Part site plan/key plan 1:200

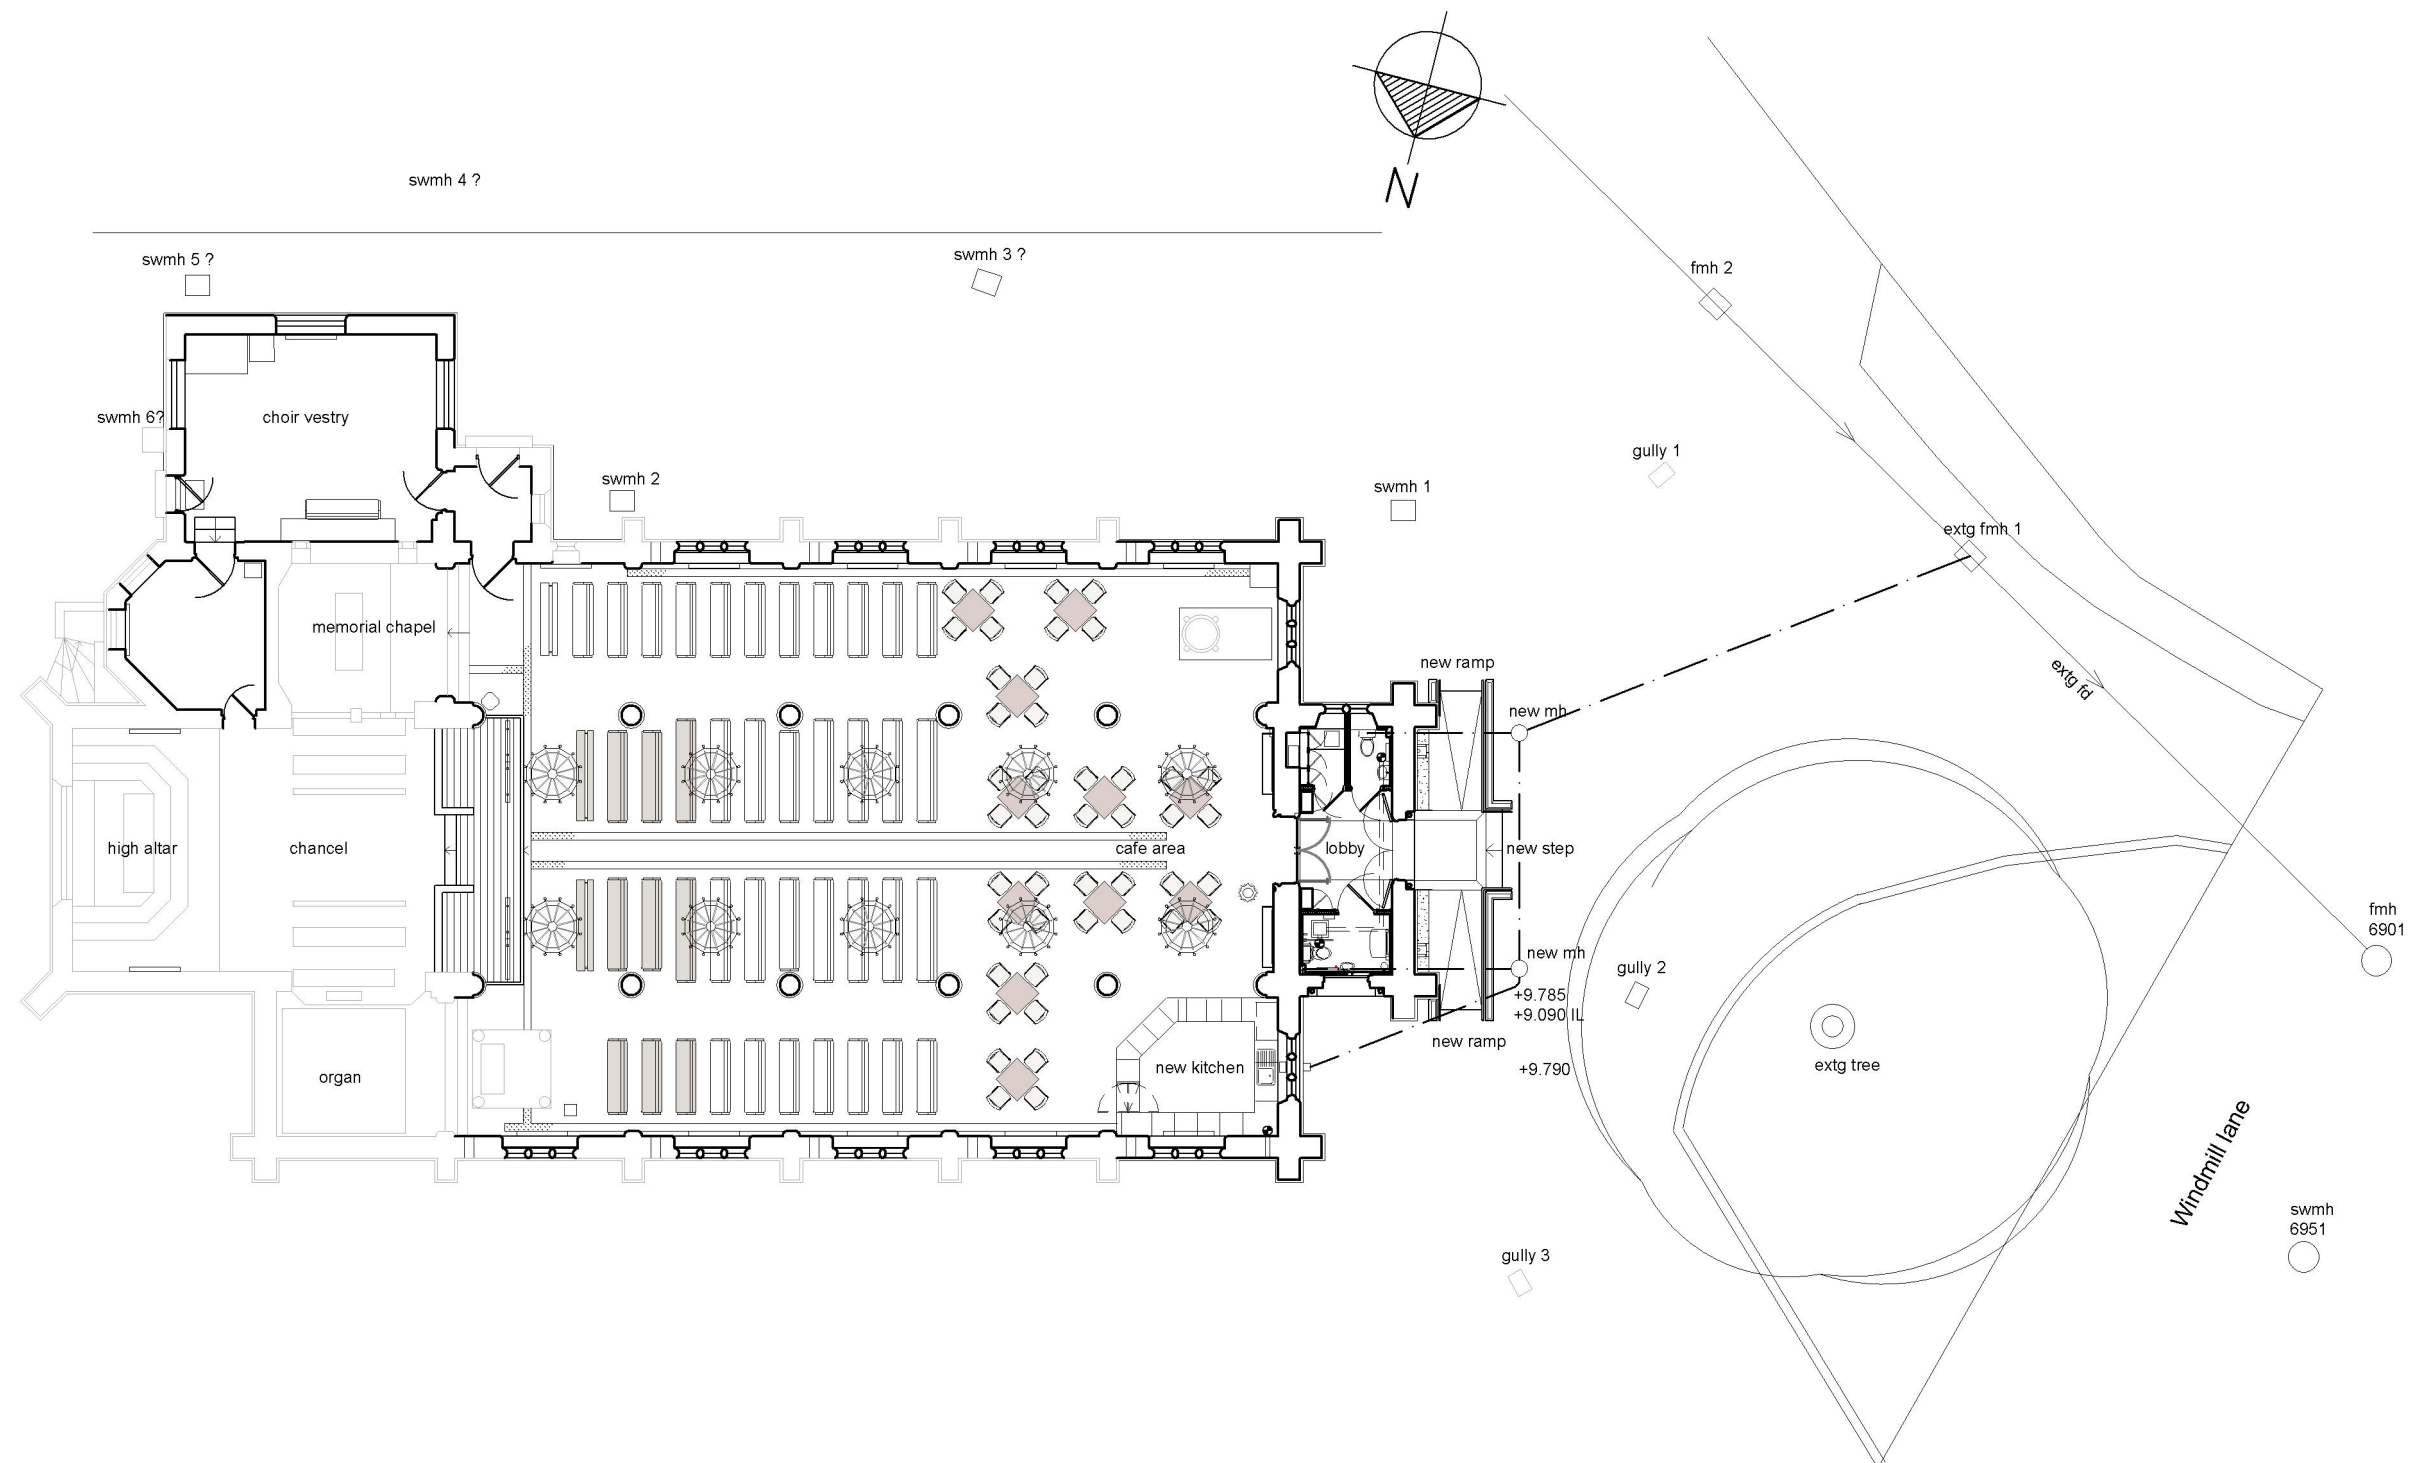
light duty covers fmh1, swmh 2, and swmh 3 needs to be medium duty covers

fmh2 steel covers needs further assessment as it cant be opened

swmh1 steel cover handle is broken and cannot be opened

swmh 1 & 2 are assumed surface water

swmh 3 to 6 to be checked and confirmed if surface water
